CONTRACT CHANGE ORDER NO. _____
SHEET ____ OF ____

MARK	DATE	DESCRIPTIONS	BY	CH'D	CCO#
2	08/20/10	BIKEPATH DETAILS	CC	TH	99
1	05/04/07	W2 CAP BEAM ISD RESOLUTION	JD	TH	34SI

SAN FRANCISCO OAKLAND BAY BRIDGE
EAST SPAN SEISMIC SAFETY PROJECT
SELF-ANCHORED SUSPENSION BRIDGE
(SUPERSTRUCTURE & TOWER)

BIKEPATH DETAILS NO.6

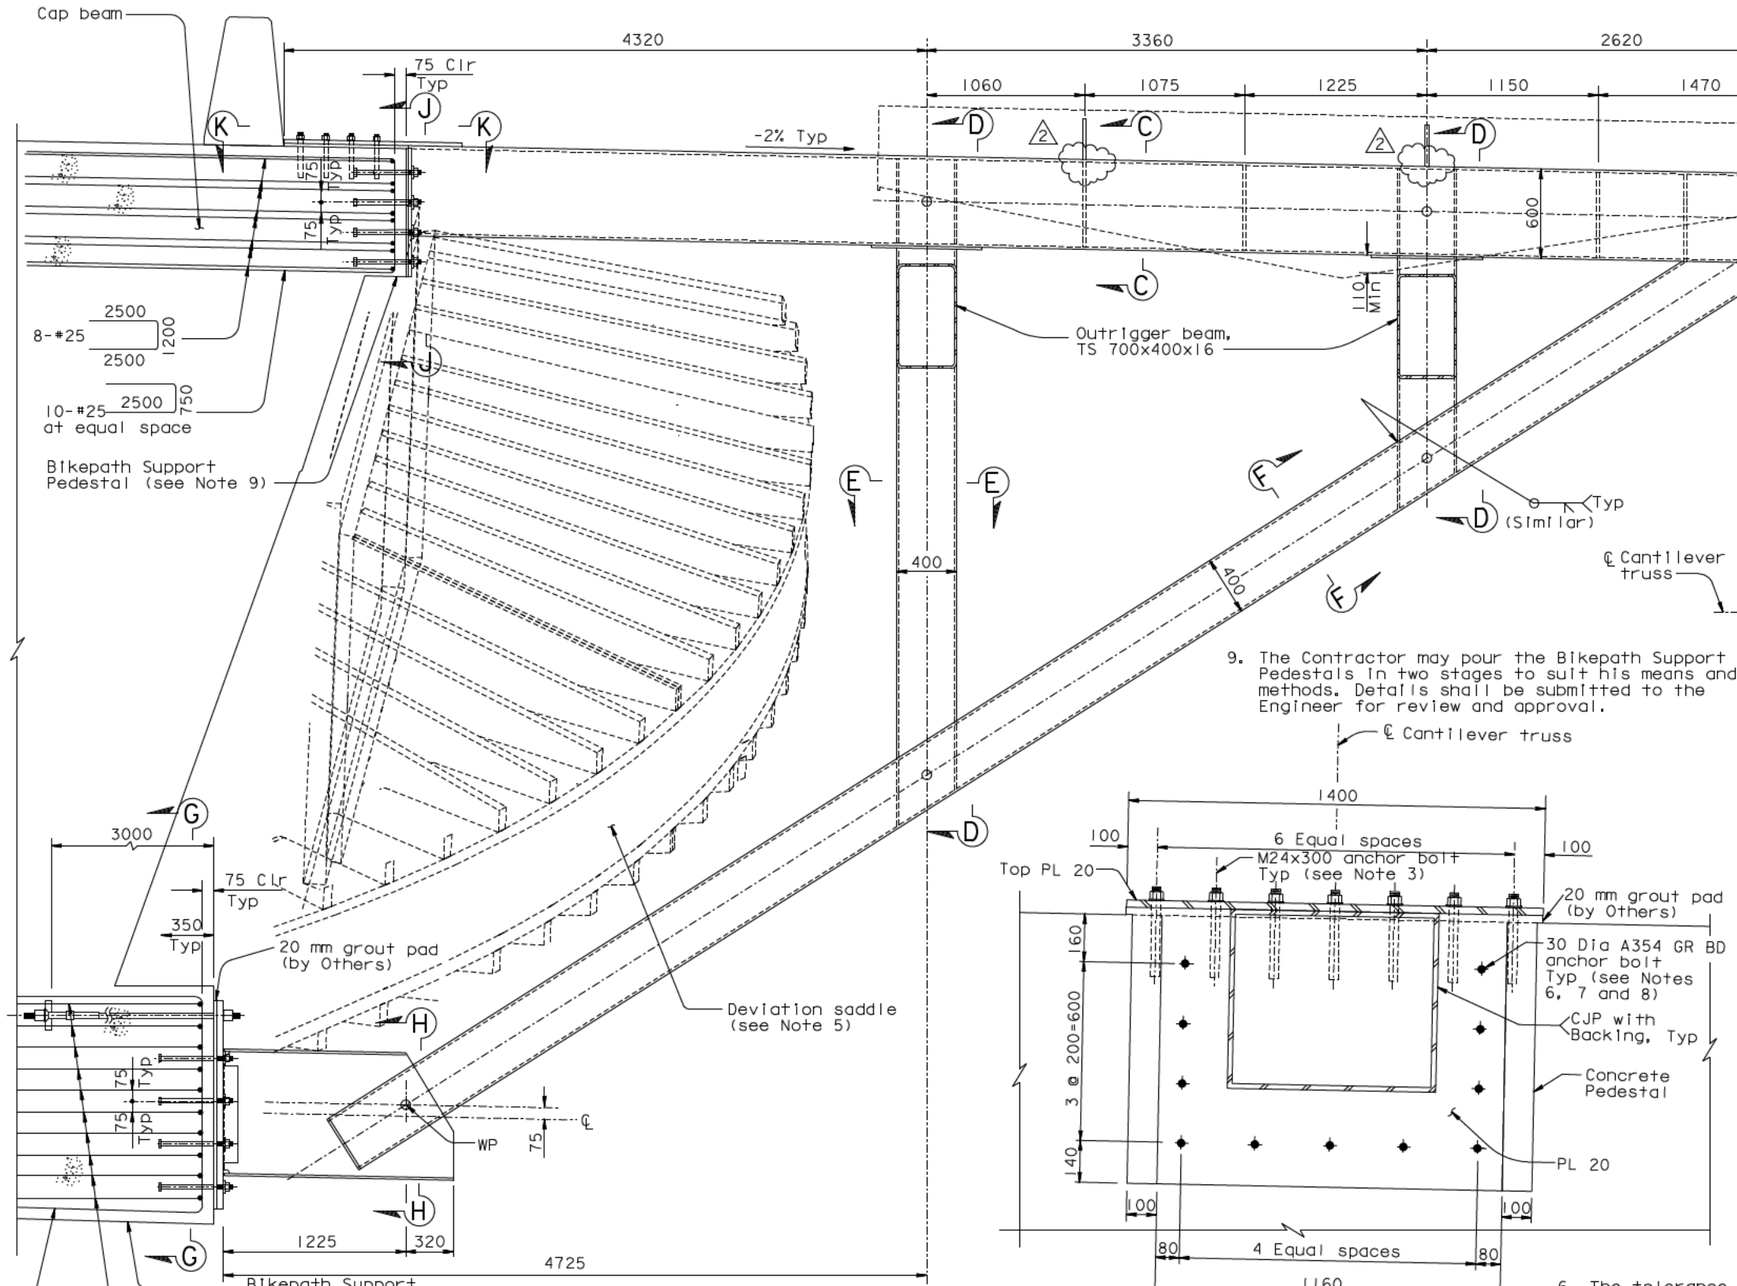
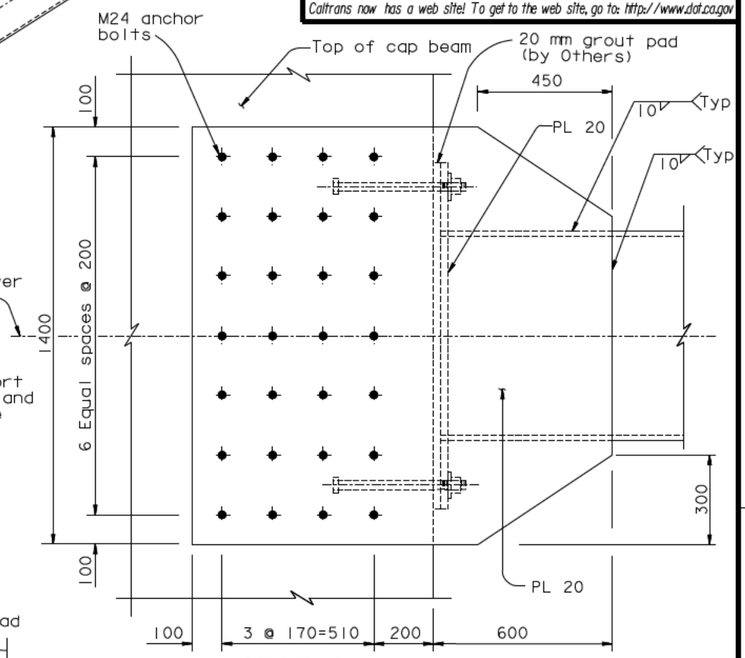
9. The Contractor may pour the Bikepath Support Pedestals in two stages to suit his means and methods. Details shall be submitted to the Engineer for review and approval.
